Model: Cattleya2		Date: 16-May-01	No.: MB023001
Modified Article: ICs on the Video Control Board		Prepared by: H.K.	
From: Technical Service Dept., GTS Division			
Reason for Modification:	<input type="checkbox"/> Parts catalog correction <input type="checkbox"/> To facilitate assembly <input type="checkbox"/> Part standardization	<input checked="" type="checkbox"/> Vendor change <input type="checkbox"/> To improve reliability <input type="checkbox"/> Other	<input type="checkbox"/> To meet standards ()

Model: Cattleya2		Date: 17-May-01	No.: MB023002
Modified Article: Feed Rollers		Prepared by: H.Matusi	
From: Technical Services Dept., GTS Division			
Reason for Modification:	<input type="checkbox"/> Parts catalog correction <input type="checkbox"/> To facilitate assembly <input type="checkbox"/> Part standardization	<input checked="" type="checkbox"/> Vendor change <input type="checkbox"/> To improve reliability <input type="checkbox"/> Other	<input type="checkbox"/> To meet standards ()

35. Fusing Unit 2 (B023)

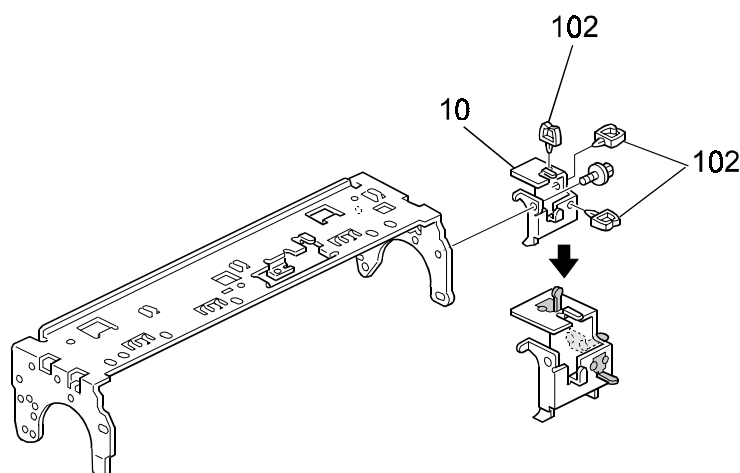
Old part number	New part number	Description	Q'ty	Int	Page	Index	Note
A2574108	B0234090	Rear Fusing Lamp Holder	1	O/O	81	10

36. Fusing Unit 3 (B023)

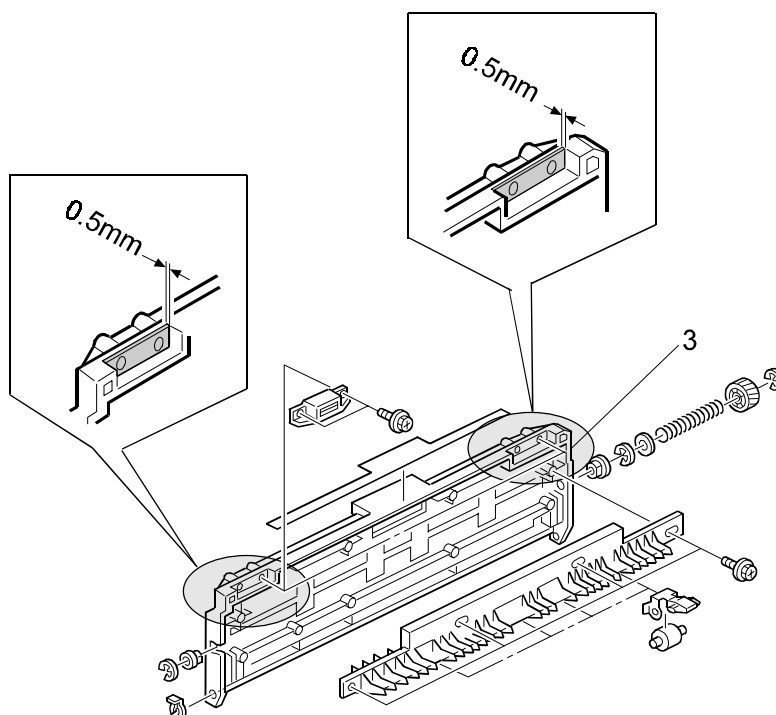
Old part number	New part number	Description	Q'ty	Int	Page	Index	Note
B0234143	B0234142	Paper Exit Unit Frame	1	X/O	83	3	
<i>B0234018</i>	<i>B0234019</i>	<i>Fusing Unit – 120V</i>	<i>1</i>	<i>X/O</i>	<i>79</i>	<i>*</i>	
<i>B0234028</i>	<i>B0234029</i>	<i>Fusing Unit – 230V</i>	<i>1</i>	<i>X/O</i>	<i>79</i>	<i>*</i>

13. Optical Section 1 (B023)

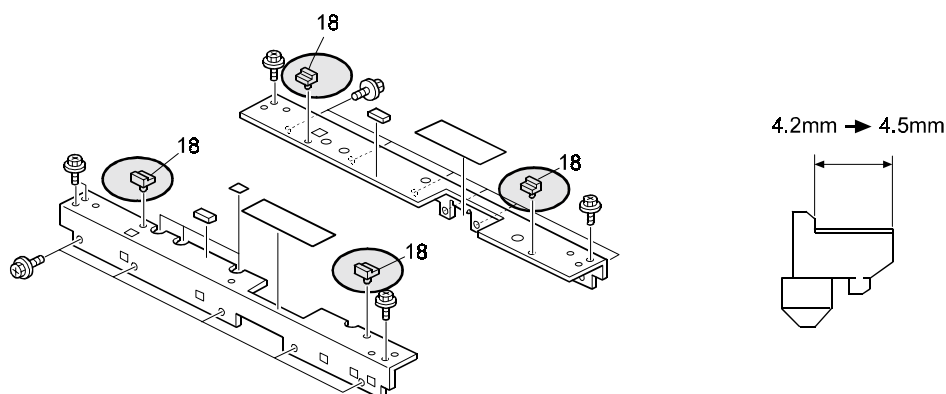
To facilitate and ensure correct factory installation of the exposure glass, the shape of the Exposure Glass Stay has been changed as shown below.

Old part number	New part number	Description	Q'ty	Int	Page	Index	Note
B0231831	B0231833	Exposure Glass Stay	4	X/O	37	18

29. Transfer Belt Cleaning 2 (B023)

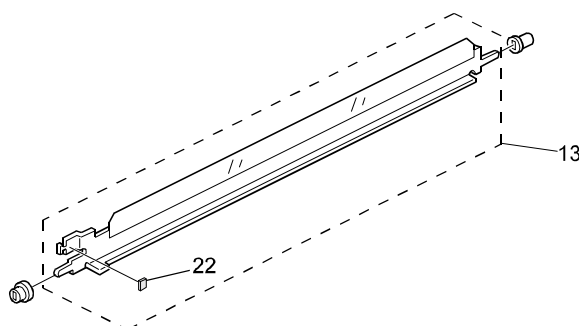
The following part has been added to the Entrance Seal to insulate it from ground.

A: Paper Discharge Plate

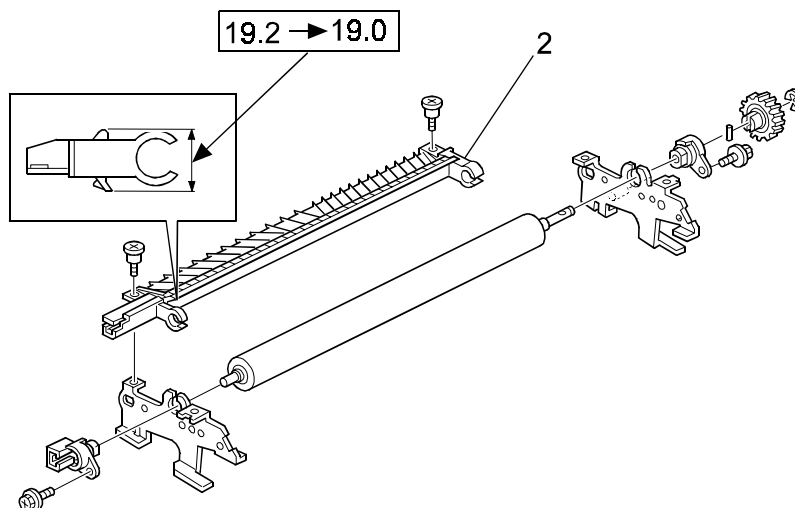
The reverse side of the duplex copy paper may sometimes roll around the transfer roller when thin paper is curled after the fusing process. To ensure good paper transportation, the production machines have been modified as follows: The following modification is done to reduce the gap between the paper discharge plate and image transport belt.

B: Front & Rear Side Plates, Left Stay, Entrance Seal

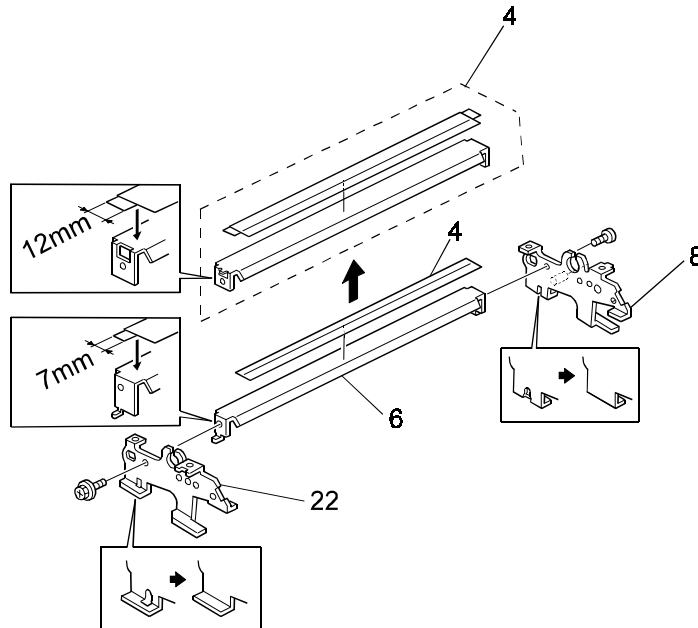
The shapes of these parts have been changed to reduce the gap. The old parts cannot be supplied. If either one of the old parts must be replaced in the field, replace all of them with new parts. As we found that it is difficult to replace the entrance seal independently in the field, we supply the entrance seal left stay, on which the entrance seal is adhered. The entrance seal itself is no longer supplied.

C: Paper Transfer Unit

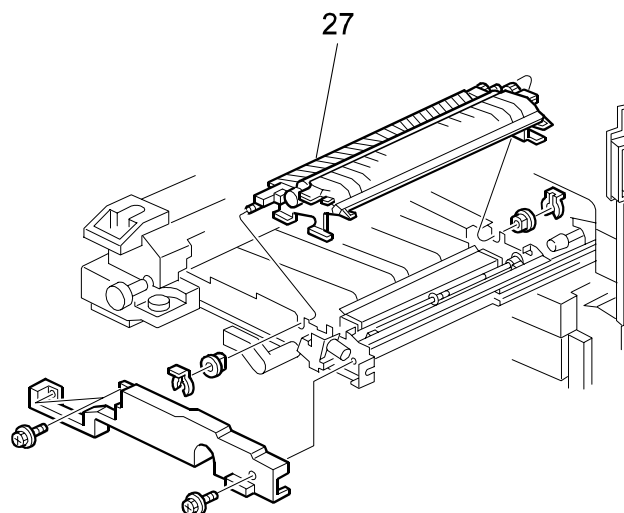
To facilitate servicing, the paper transfer unit is supplied as a spare parts. It contains the above modified new parts.

35. Fusing Unit 2 (B023)

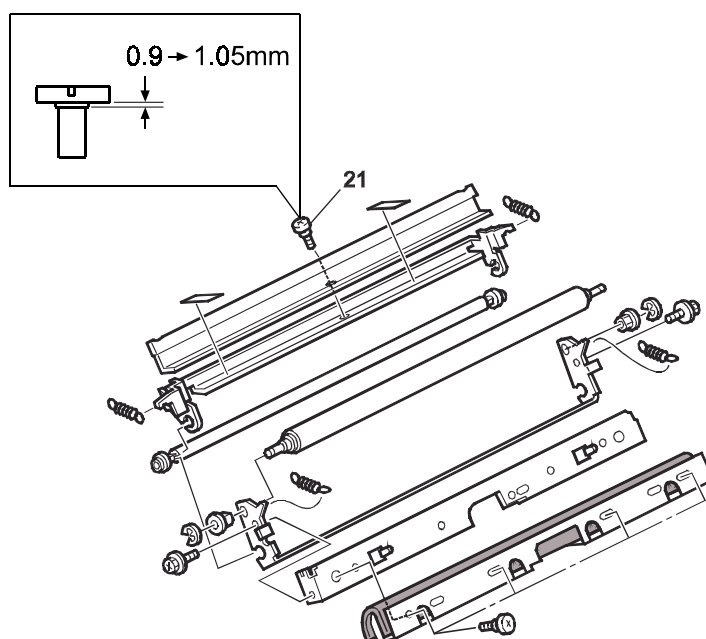
Old part number	New part number	Description	Q'ty	Int	Page	Index	Note
AA143516	AA143527	Stepped Screw – M4	1	X/O	81	21	
B0234019	B0234020	Fusing Unit – 120V	1	X/O	79	*	
B0234029	B0234030	Fusing Unit – 230V	1	X/O	79	*

26. Transfer Belt Cleaning 2 (B023)

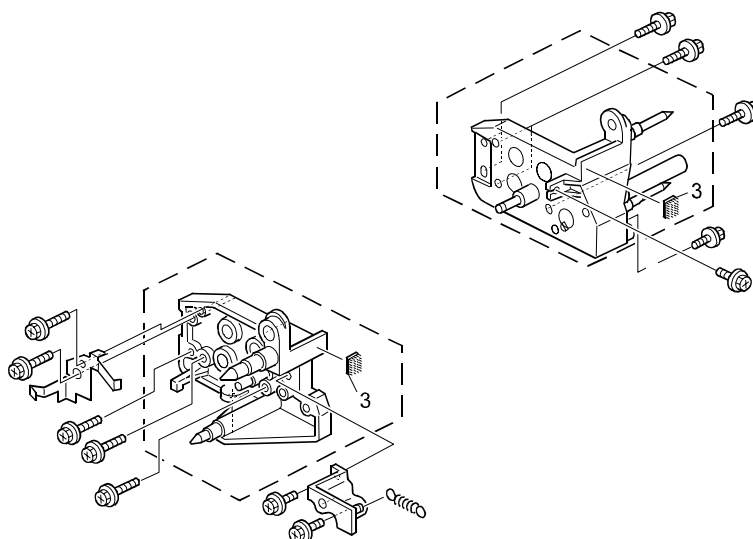
Old part number	New part number	Description	Q'ty	Int	Page	Index	Note
A2576386	<i>B0236386</i>	Slide Plate Seal	2	O/O	69	3

28. Transfer Belt Cleaning 1 (B023)

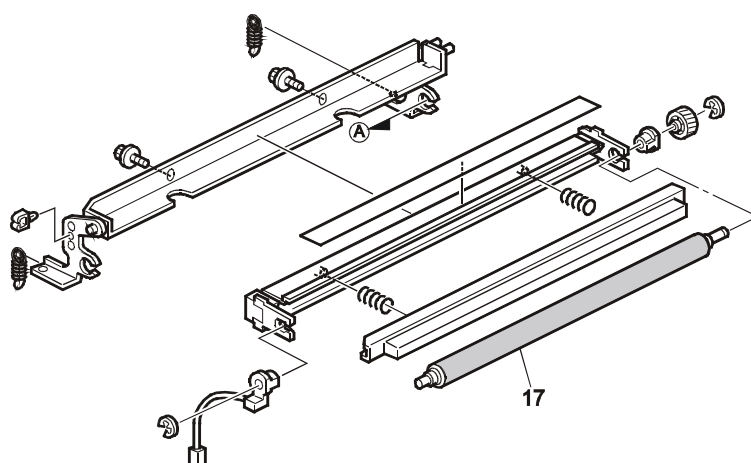
Old part number	New part number	Description	Q'ty	Int	Page	Index	Note
B0236358	B0236359	Transfer Belt Brush Roller Brush Roller – Transfer Belt	1	X/O	67	17	
B0236350	B0236451	Cleaning Unit	1	X/O	67	*

2. Exterior 2 (B023)

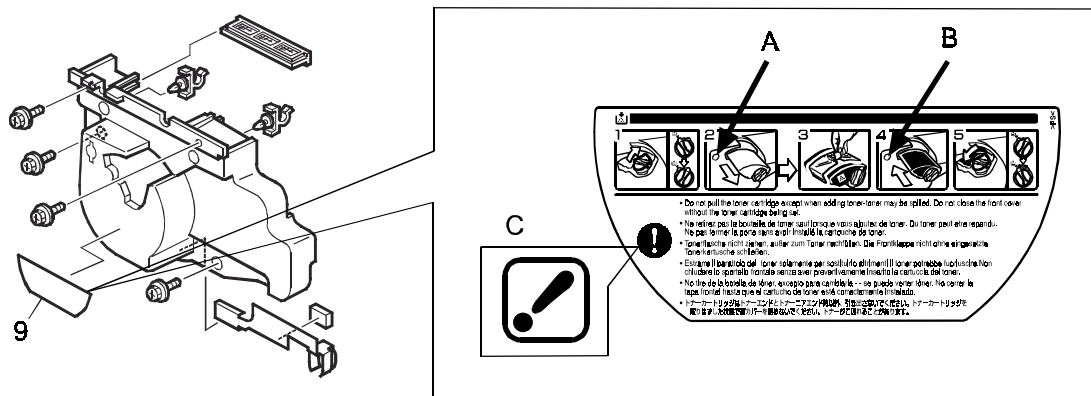
To prevent potential user operation mistakes, 2 illustrations on the toner replenishment decal [A and B below] have been removed, and the caution mark [C] has been slightly modified.

35 Fusing Unit 2 (B023)

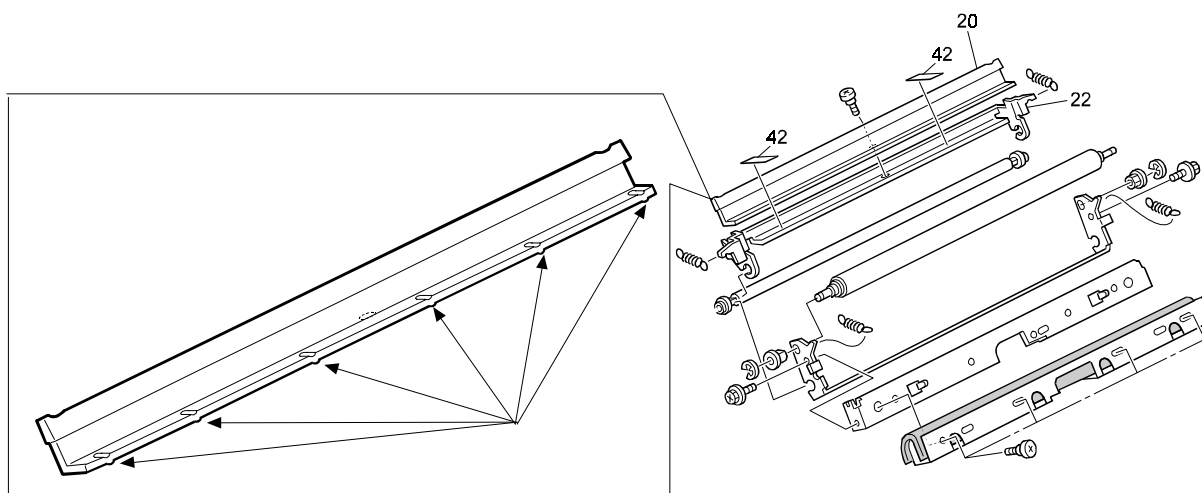
To facilitate assembly, 6 small convex parts have been added to the Fusing Blade Assembly. These will perform the function of the Holder Seals on the old Blade Holder.

Note: When installing the new AE043013 Blade Assembly, remove the Holder Seals (if present) from the Blade Holder, as these are not needed with the new Assembly.

47. Drive Section 5 (B023)

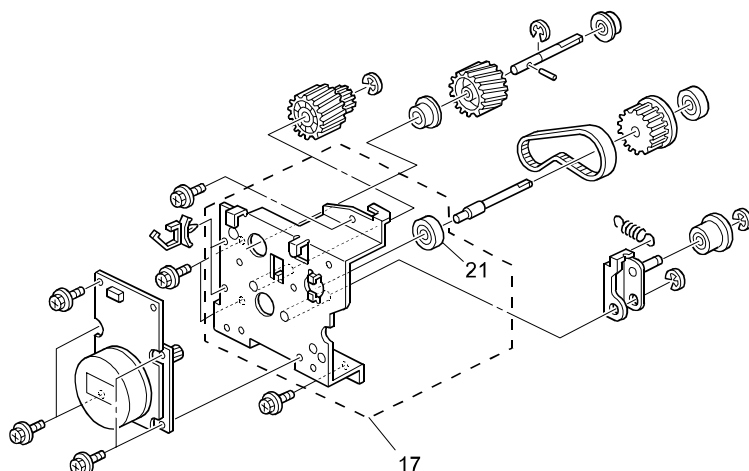
The Ball Bearing (21) should be included in the Drive Bracket (17):

25. Drawer Unit 3 (B023)

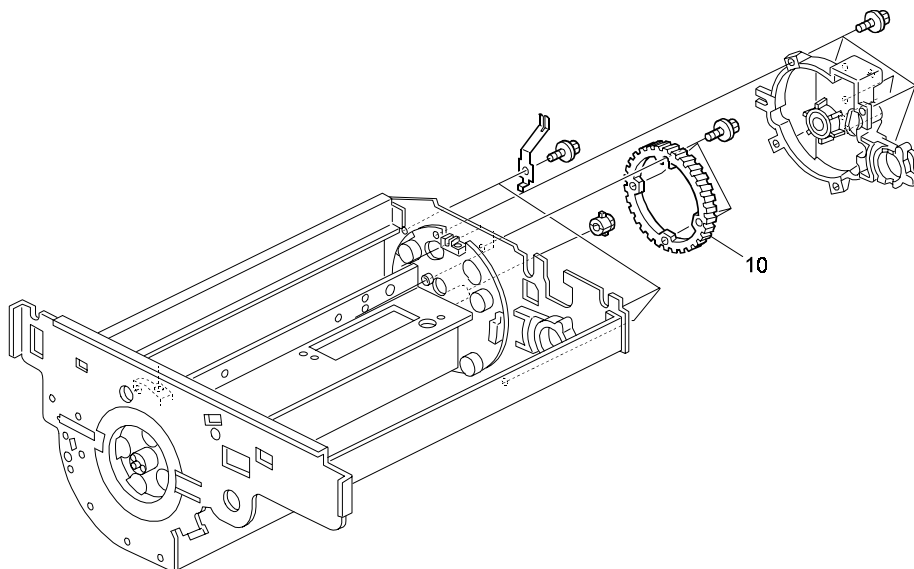
Please delete the following part from your Parts Catalogs.

Old part number	New part number	Description	Q'ty	Int	Page	Index	Note
B0233212		Frame Gear – Development Unit	1		61	10

22. DRUM CLEANING UNIT (B023)

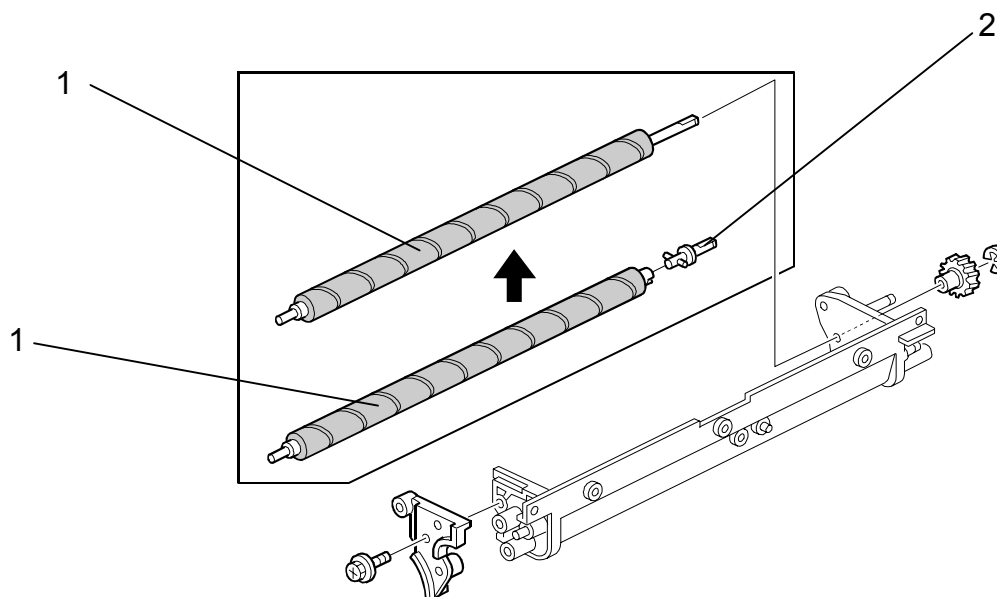
The Drive Shaft for the Drum Cleaning Brush can sometimes get scraped by the e-ring, which causes insufficient drive to be transferred to the brush. To continually ensure proper drive transfer, the Drive Shaft has been made part of the Drum Cleaning Brush, and this modification applied to the production line (see cut-in S/N below).

58. Frame Section 3 (B023)

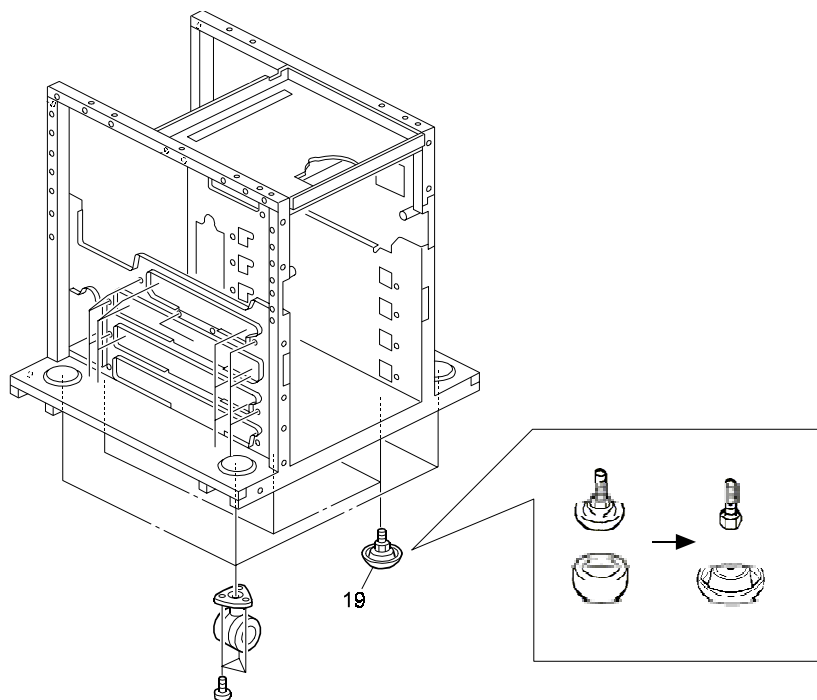
Old part number	New part number	Description	Q'ty	Int	Page	Index	Note
54241064	AA143779	Screw Stand	4→4	O/O	127	19	
	B0231101	Hexagonal Bolt – M12X30					
		Stand Holder	2		127	27	New

19. Toner Hopper (B023)

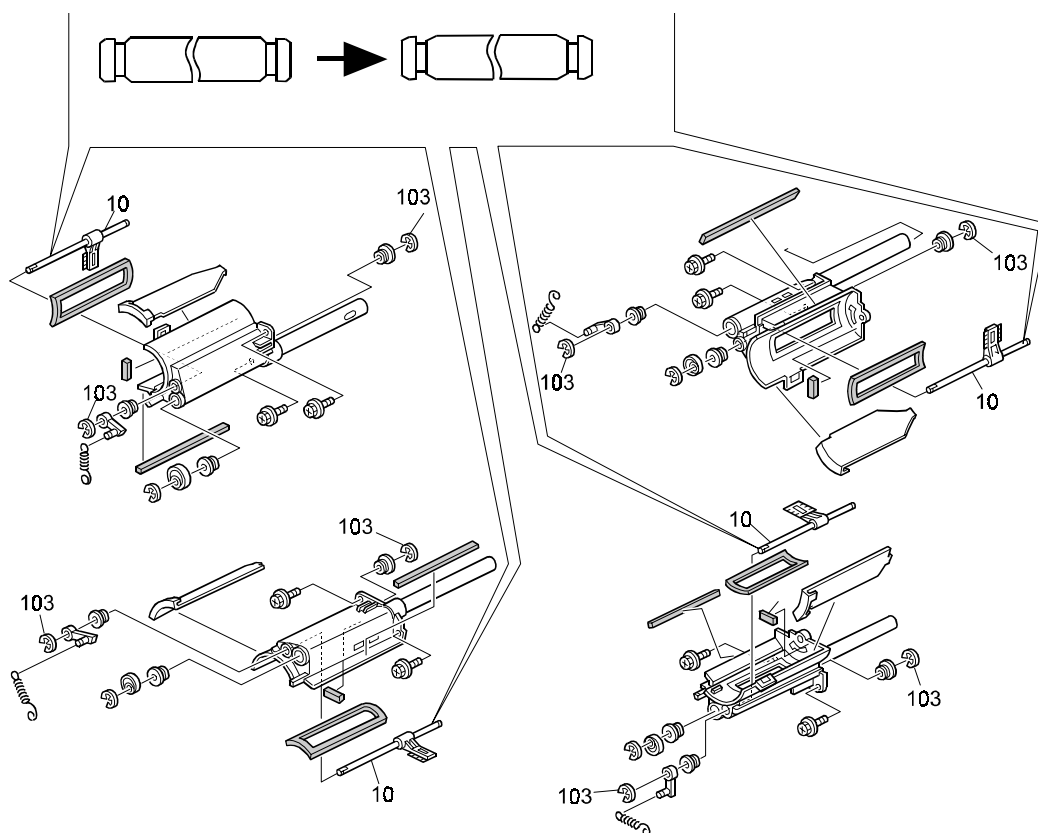
To ensure that the toner seal is not damaged at the factory, the shape of the shafts for the Toner End Stopper Cleaner has been changed as shown below. Due to this change, the Retaining Ring has been changed from an M3 to an M2.5 type.

Old part number	New part number	Description	Q'ty	Int	Page	Index	Note
A2573318	B0233318	Cleaner – Toner End Stopper	4→4	X/X	49	10	
07200030B	07200025B	Retaining Ring – M3 Retaining Ring – M2.5	8→8	X/X	49	103

55. ELECTRICAL SECTION 7 (B023)

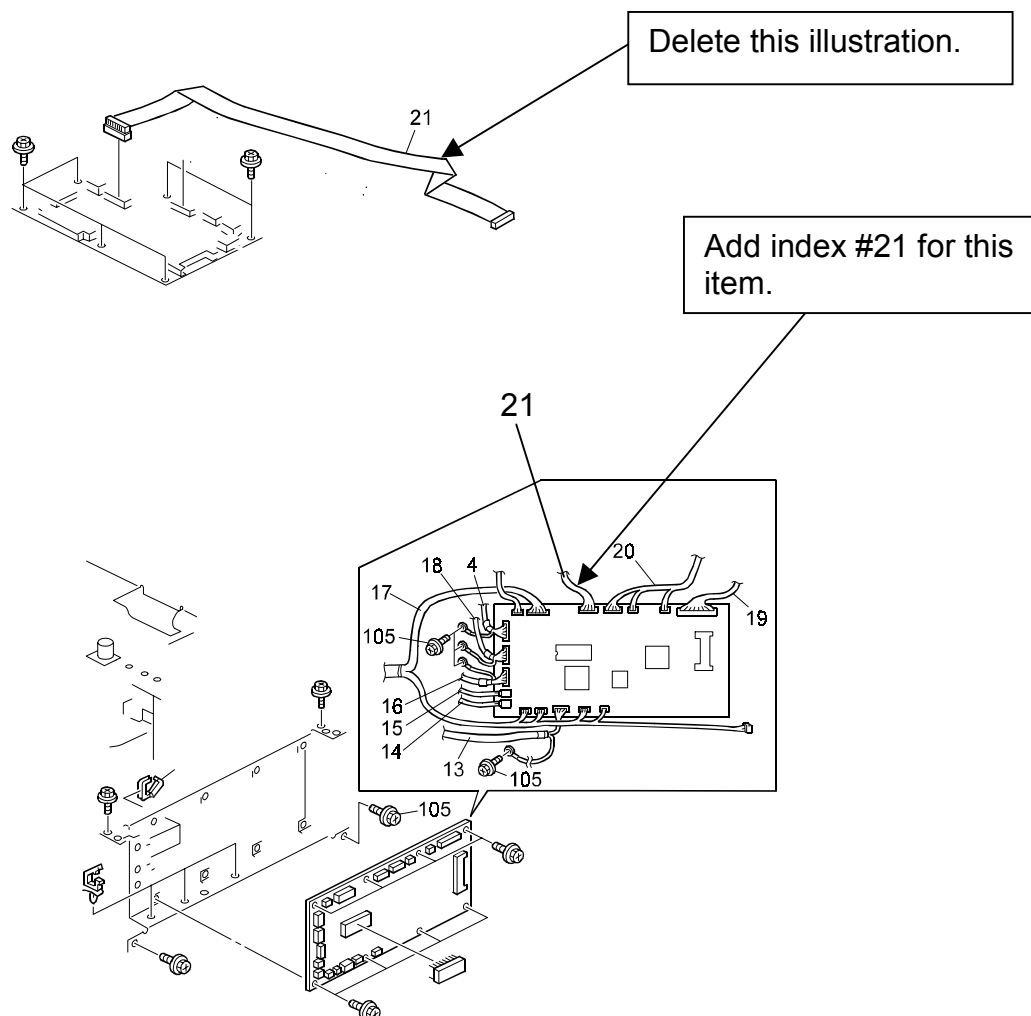
Incorrect part number	Correct part number	Correct Description	Q'ty	Page	Index	Note
B0235377	B0235368	IPU Video Harness	2-1	39	24	
B0235368	B0235377	IPU Scanner System Control Harness	6-1	121	21

Illustration for B0235377 (IPU Scanner System Control Harness):

34. FUSING UNIT1 (B023)

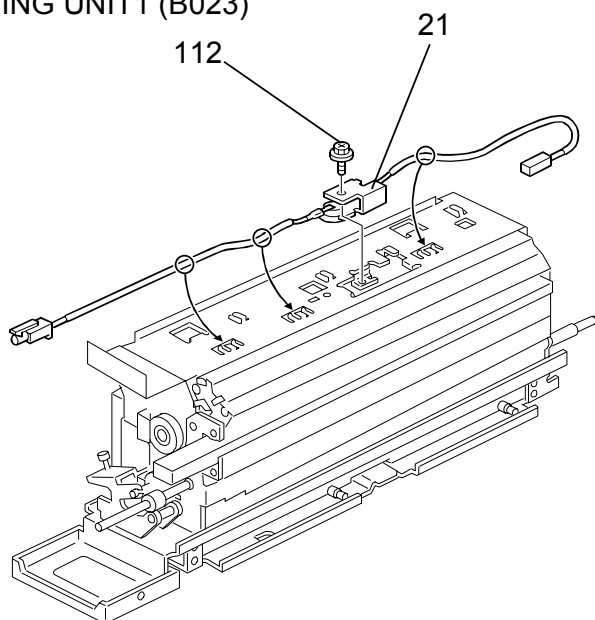
To increase the reliability of SC542/547 detection, the fusing unit Thermofuse has been changed to a Thermostat. In accordance with this change, the related harnesses and screws have also been changed.

Old part number	New part number	Description	Q'ty	Int	Page	Index	Note
<i>B0234021</i>	<i>B0234022</i>	<i>Fusing Unit – 120V</i>	<i>1</i>	<i>X/O</i>	<i>79</i>	<i>*</i>	
<i>B0234031</i>	<i>B0234032</i>	<i>Fusing Unit – 230V</i>	<i>1</i>	<i>X/O</i>	<i>79</i>	<i>*</i>	
B0234162	B0234170	Thermostat – Hot Roller	1-1	X/O	79	21	
	09503005B	Philips Screw With Spring Washer	1	-	79	112	New
B0235311	B0235394	Fusing Unit Harness	1-1	X/O	79	24	
	08010149	Philips Pan Head Screw – M4X6	1	-	79	113	New
AA000219		Fusing Thermofuse Decal	1-0	-	79	22	
B0235393	B0235395	Defumidifier Harness	1-1	X/O	117	15	
	08010149	Philips Pan Head Screw – M4X6	1	-	117	110	New

1. Exterior 1 (B023)

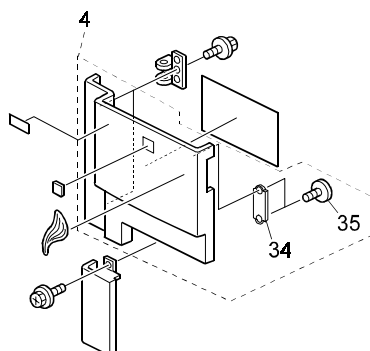
Old part number	New part number	Description	Q'ty	Int	Page	Index	Note
	B0231275	Fixing Plate – Magnetic Catch	1		13	34	
	B0231276	Screw – M5x30	2		13	35

17. LD Unit (B032)

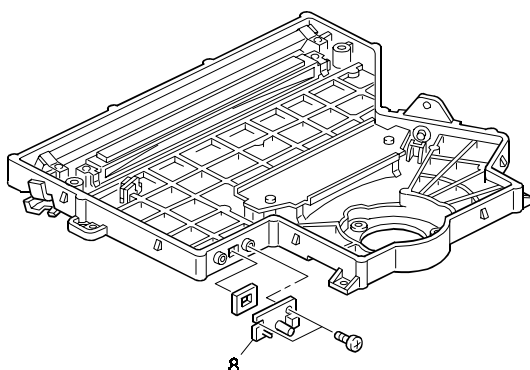
To further increase the accuracy of laser synchronization, the register on the Synchronization Detector Board has been modified.

Old part number	New part number	Description	Q'ty	Int	Page	Index	Note
A2575290	B0235290	Synchronization Detector Board	1	X/O	45	8
